ENG-SP22004-R1-PDR.pdf Markup Summary

1 (2)		
PCD Project No. SP-22-004	Subject: Text Box Page Index: 1 Date: 8/2/2022 6:05:11 PM Author: CDurham Color: Layer: Space: Page Label: 1	SP-22-004
(Coordinate with SKP-22-004 comments)	Subject: Text Box Page Index: 1 Date: 8/17/2022 2:26:42 PM Author: dsdrice Color: Layer: Space: Page Label: 1	(Coordinate with SKP-22-004 comments)
6 (4)		
he large acreage north up to the top d flows within Sand Creek that are y show. These flows are as follows: pment[Q ₄ = 430 cf.Q ₄ = 1487 cf. 1911 (cf. Noveer, the focus of this ivelopment proposed. As mentioned Fork of Sand Creek. The following	Subject: Highlight Page Index: 6 Date: 8/4/2022 11:36:45 AM Author: CDurham Color: Layer: Space: Page Label: 6	Q10 = 430 cfs Q100 = 1487 cfs
e top E are lows: — Flows do not maich MDDP except shown DDP scorpt shown d this — angendar. Soe d shunge meo. oned wwing	Subject: Callout Page Index: 6 Date: 8/4/2022 11:38:00 AM Author: CDurham Color: Layer: Space: Page Label: 6	Flows do not match MDDP excerpt shown in appendix. See comments on drainage map.

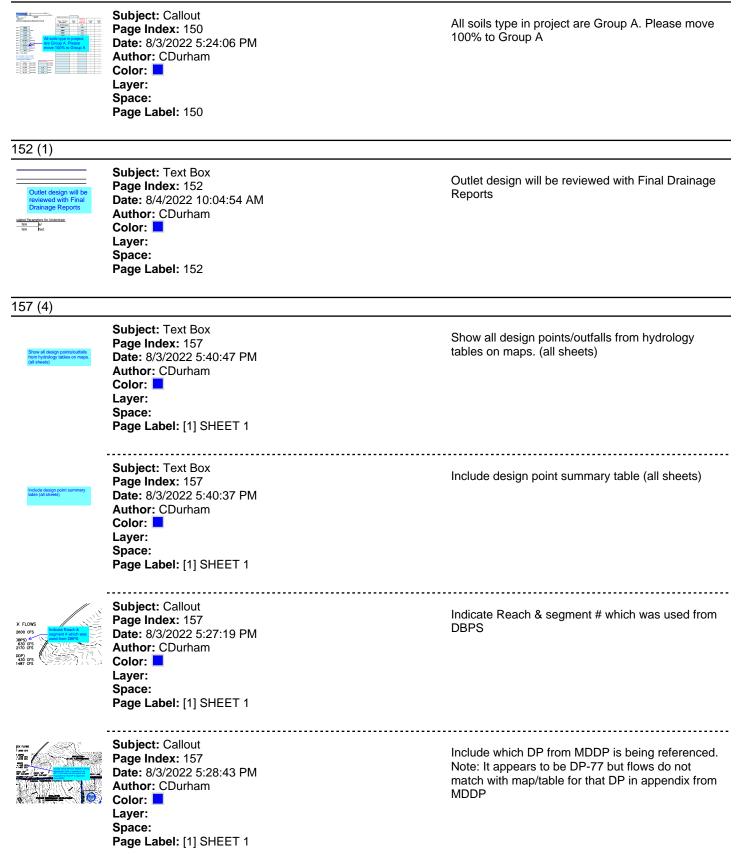
All soils type in project are Group A. Please move 100% to Group A

Outlet design will be reviewed with Final Drainage Reports

Flows shown do not match those shown on developed drainage map. Confirm which flows are correct and update as needed.

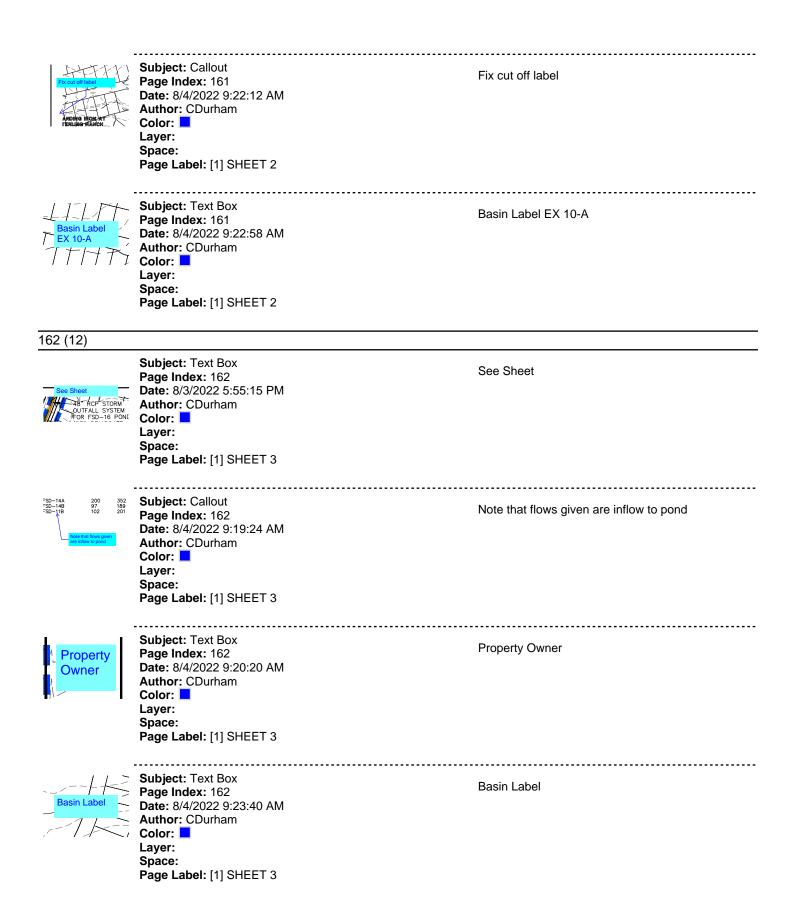
Subject: Text Box Page Index: 161 Date: 8/3/2022 5:54:56 PM Author: CDurham Color: Layer: Space: Page Label: [1] SHEET 2	See Sheet
See Sheet	Subject: Text Box Page Index: 161 Date: 8/3/2022 5:55:04 PM Author: CDurham Color: Layer: Space: Page Label: [1] SHEET 2	See Sheet
Basin Label	Subject: Text Box Page Index: 161 Date: 8/4/2022 9:17:17 AM Author: CDurham Color: Layer: Space: Page Label: [1] SHEET 2	Basin Label
Property Owner	Subject: Text Box Page Index: 161 Date: 8/4/2022 9:17:34 AM Author: CDurham Color: Layer: Space: Page Label: [1] SHEET 2	Property Owner
RUM ADDR RUMAN	Subject: Highlight Page Index: 161 Date: 8/4/2022 9:17:57 AM Author: CDurham Color: - Layer: Space: Page Label: [1] SHEET 2	
Per map, should be Basin TR-W, not TR-V R-V SC-4	Subject: Callout Page Index: 161 Date: 8/4/2022 9:18:20 AM Author: CDurham Color: Layer: Space: Page Label: [1] SHEET 2	Per map, should be Basin TR-W, not TR-V

Subject: Callout Note that flows given are inflow to pond ND ESD-16 Page Index: 161 Date: 8/4/2022 9:18:59 AM Author: CDurham Color: Layer: Space: Page Label: [1] SHEET 2 Subject: Callout OND FSD-148 Note that flows given are inflow to pond Page Index: 161 Date: 8/4/2022 9:19:15 AM Author: CDurham Color: Layer: Space: Page Label: [1] SHEET 2 Subject: Text Box Property Owner Page Index: 161 erty Owner Date: 8/4/2022 9:20:07 AM Author: CDurham Color: 📘 Layer: Space: Page Label: [1] SHEET 2 Subject: Callout Include County project # Page Index: 161 Date: 8/4/2022 9:21:06 AM Author: CDurham Color: Layer: Space: Page Label: [1] SHEET 2 Subject: Callout Foursquare? Page Index: 161 Date: 8/4/2022 9:21:34 AM Author: CDurham Color: Laver: Space: Page Label: [1] SHEET 2 Subject: Callout Villages? Page Index: 161 Date: 8/4/2022 9:21:40 AM Author: CDurham Color: Layer: Space: Page Label: [1] SHEET 2
